DESCRIPTION:
Ltr notarized 3-8-74, re their 11-30-73, 12-31-73, & 1-25-74 ltr.....furnishing addl info to Tech Spec 3.5.2, regarding rev rod withdrawal limits.....w/atcmts.....

PLANT NAME: Oconee Units 1 & 2

Re: Oconee Nuclear Station
Units 1 and 2
Docket Nos. 50-269 and -270

CONTROL ROD GROUP WITHDRAWAL
LIMITS FOR 3 AND 2 PUMP OPERATION

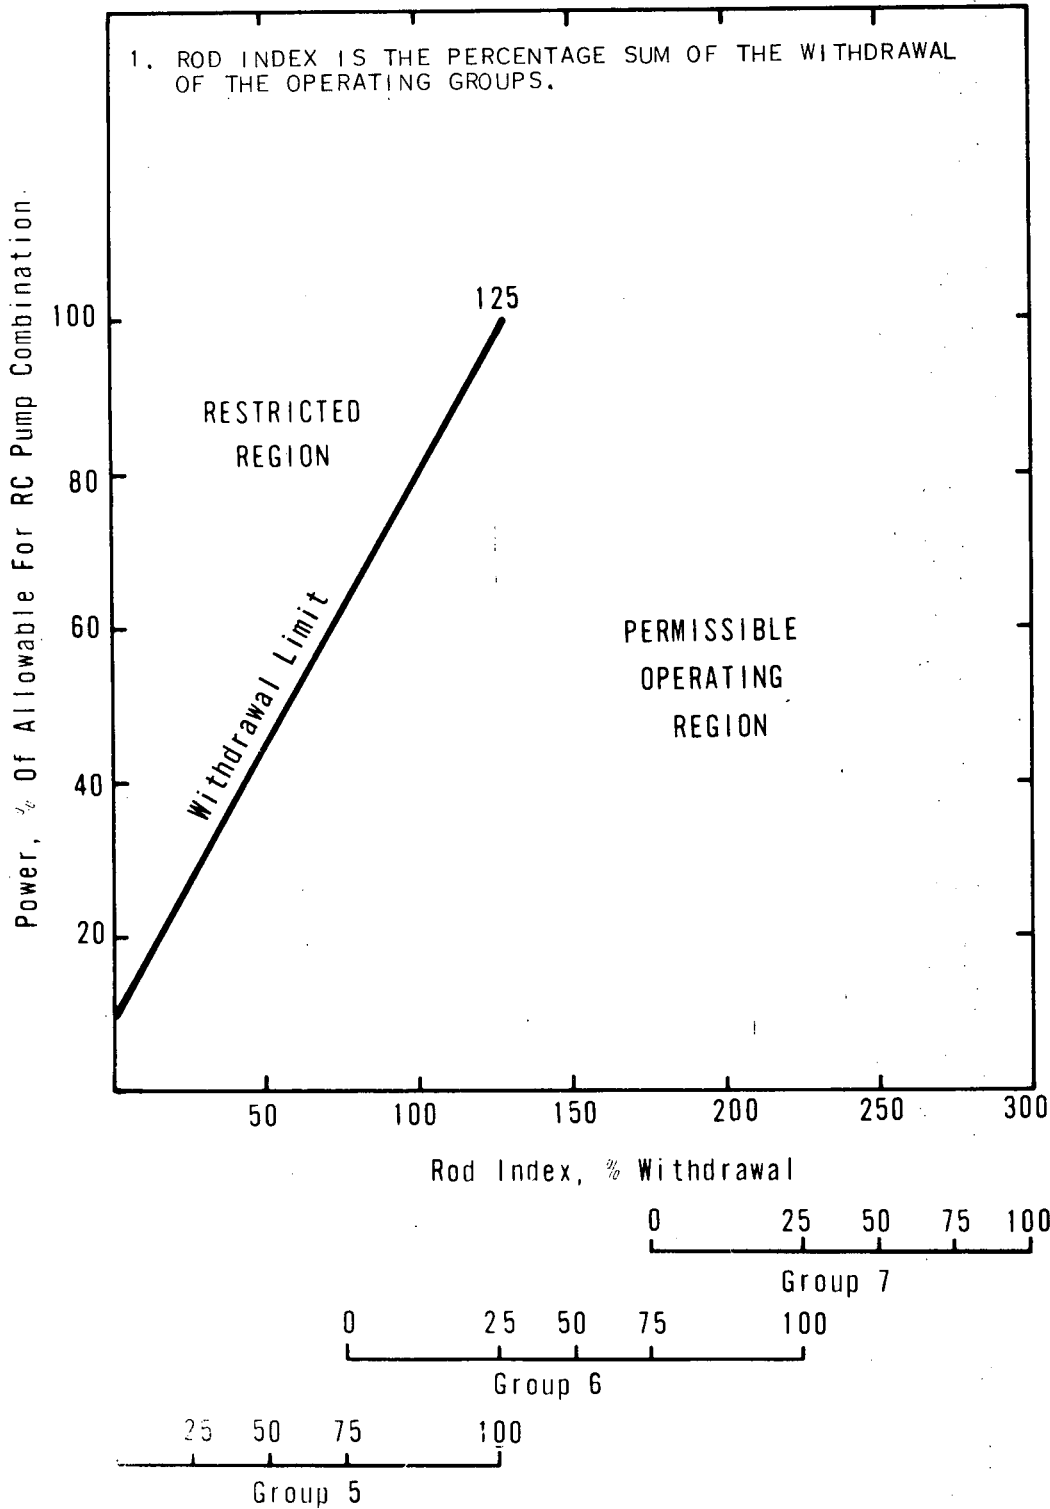
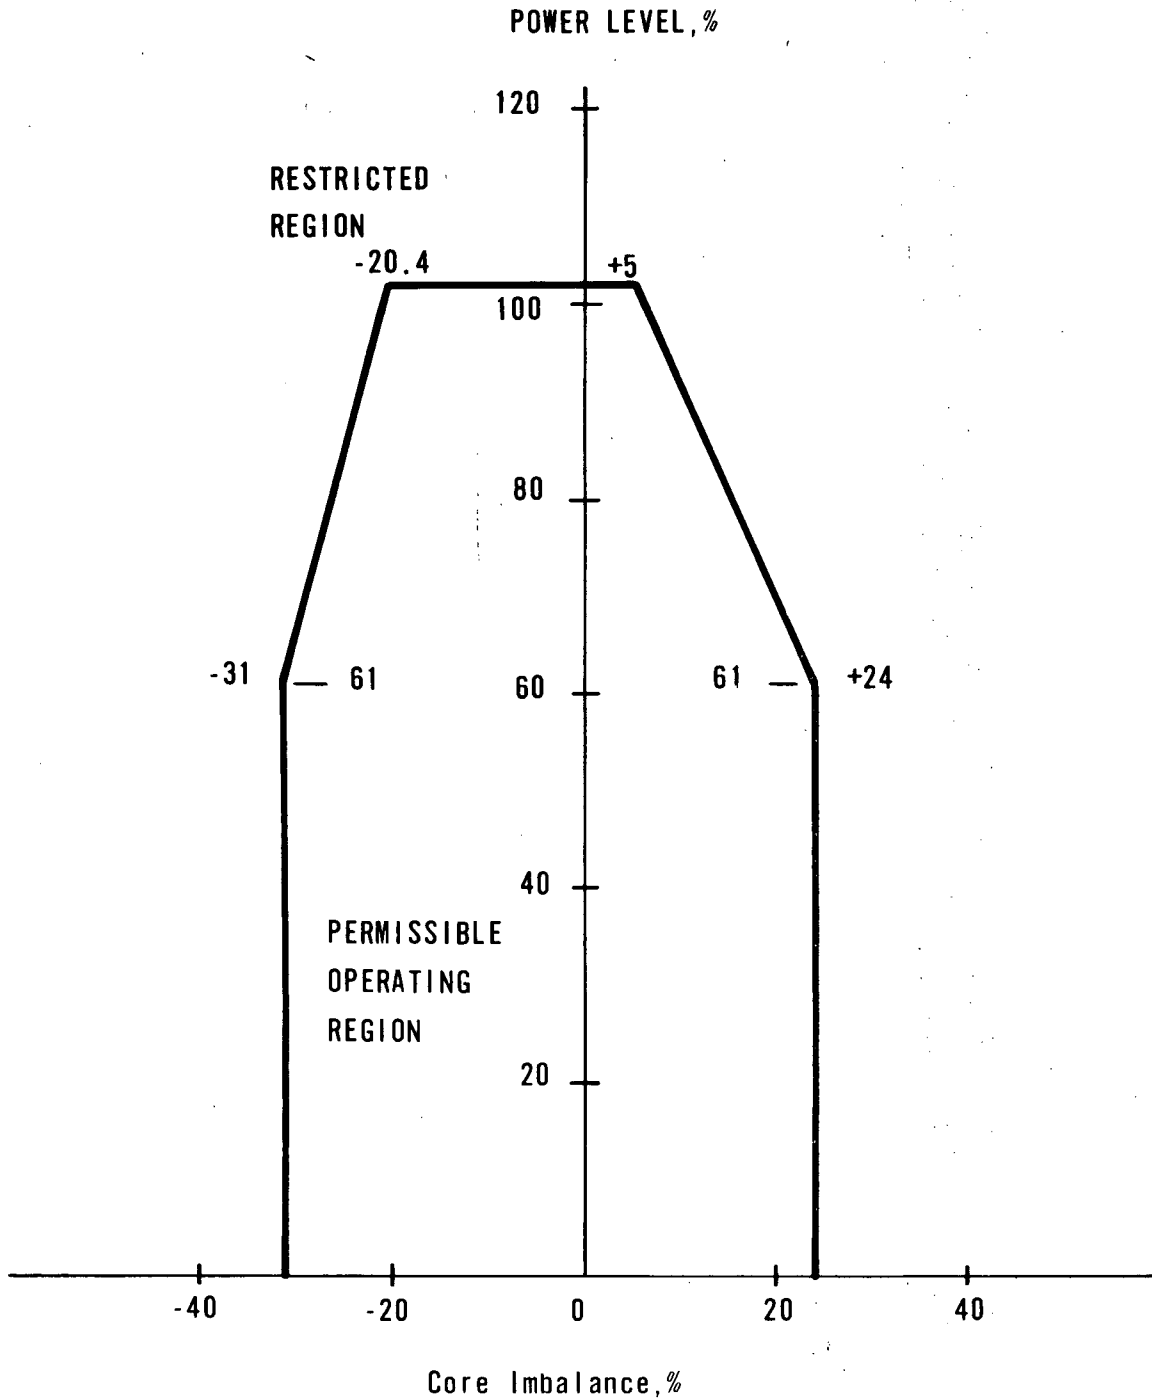
Please refer to my letters of November 30, 1973, December 31, 1973, and January 25, 1974 to you and Mr. J. F. Mallay's letter of February 21, 1974 to Mr. Al Schwencer. In my letters of November 30 and December 31, we requested certain changes to the Oconee Units 1 and 2 Technical Specifications. These changes involved Technical Specification 3.5.2 and principally revised rod withdrawal limits for both Units 1 and 2.

A reanalysis of the Oconee 1 and 2 operating margins with respect to the revised LOCA limit curve was performed by B&W using the procedures developed in BAW-10078. This analysis shows that the revised LOCA limit could have been exceeded assuming licensed design conditions early in plant life. However, based on Oconee 1 and 2 operation, these design conditions are known to be conservative and to exceed their limits and would have required the simultaneous existence of several "worst case" uncertainties. A review of operating data shows that the actual experienced quadrant power tilt for Unit 1 and the achieved power level for Unit 2 preclude the Interim Acceptance Criteria being exceeded. In order for Oconee 2 to operate within the revised LOCA limit and to more accurately reflect the operating characteristics of Oconee 1 and 2 experience to date, revised technical specifications are attached. As identified in my letter of November 30, 1973, increased flexibility in power maneuvering over the existing approved technical specification is provided by a reduction in quadrant power tilt. The attached technical specifications for Unit 2 supersede those attached to my letter of December 31, 1973.

- c. Except for physics tests or exercising control rods, the control rod withdrawal limits are specified on Figures 3.5.2-1A1, 3.5.2-1B1, 3.5.2-1A2, and 3.5.2-1B2 for four pump operation and on Figure 3.5.2-2A and 3.5.2-2B for three or two pump operation. If the control rod position limits are exceeded, corrective measures shall be taken immediately to achieve an acceptable control rod position. Acceptable control rod positions shall be attained within four hours.
- d. Except for physics tests, power shall not be increased above the power level cutoff (see Figures 3.5.2-1) unless the xenon reactivity is within 10% of the equilibrium value for operation at rated power and asymptotically approaching stability.

Figure 3.5.2-4

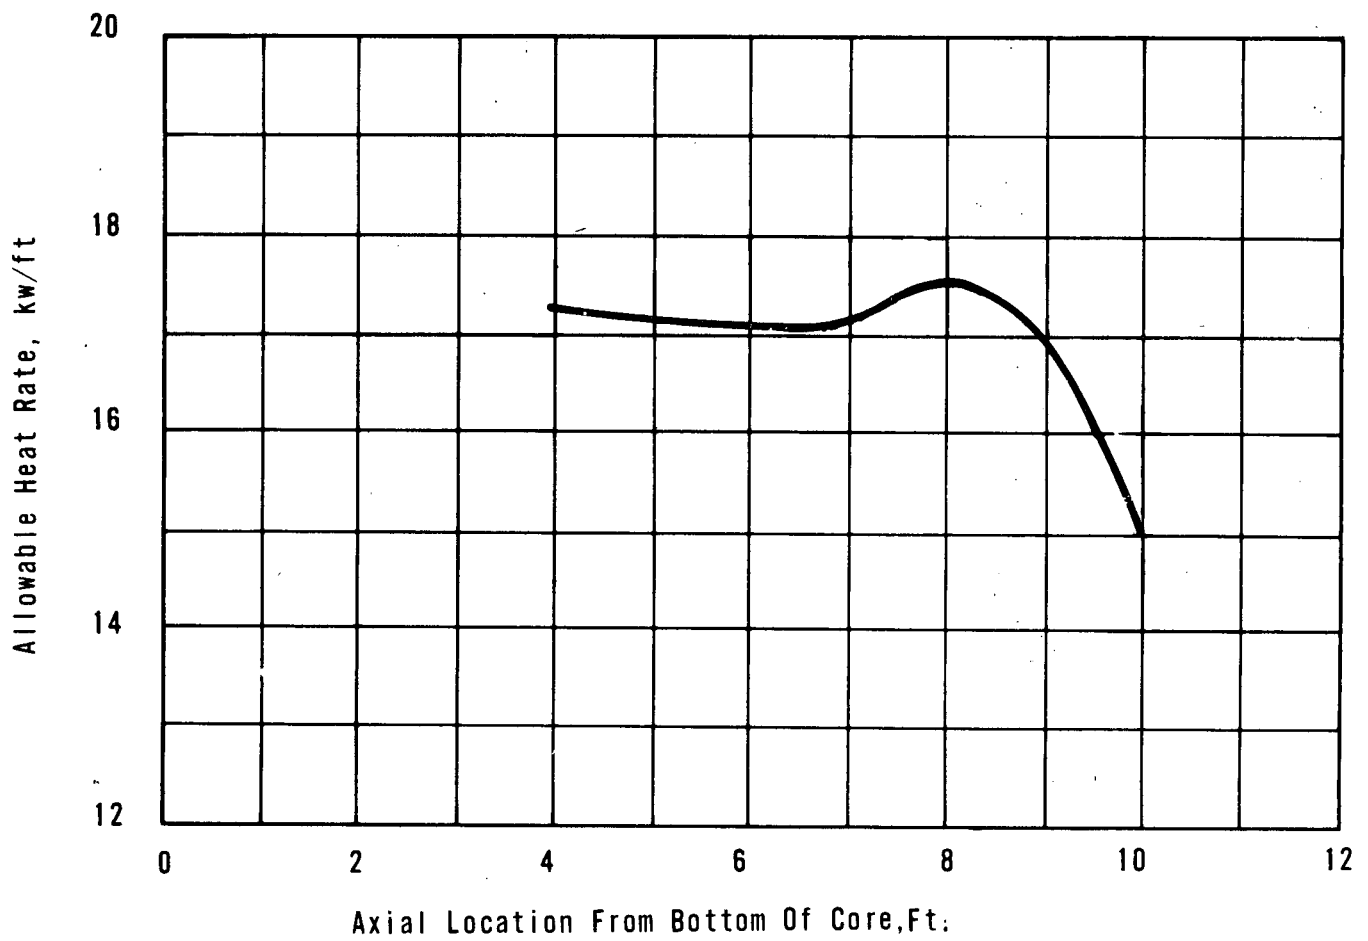
3. For the four-pump coastdown transient, the increased specific heat value had no significant effect.
4. For emergency core cooling analysis, the impact of the specific heat revision on safety limits was to lower some portions of the allowable linear heat rate by up to 0.65 kw/ft. The attached curve identified as "LOCA Limited Maximum Allowable Linear Heat Rate" determines the allowable linear heat rate as a function of elevation in the core. The revised linear heat rate is in compliance with the interim acceptance criteria. The revised LOCA limits were determined by repeating the Oconee 2 calculations. The allowable heat rate curve for Oconee 2 is lower by .65 kw/ft at the six foot elevation but is unchanged at the 10 foot elevation.
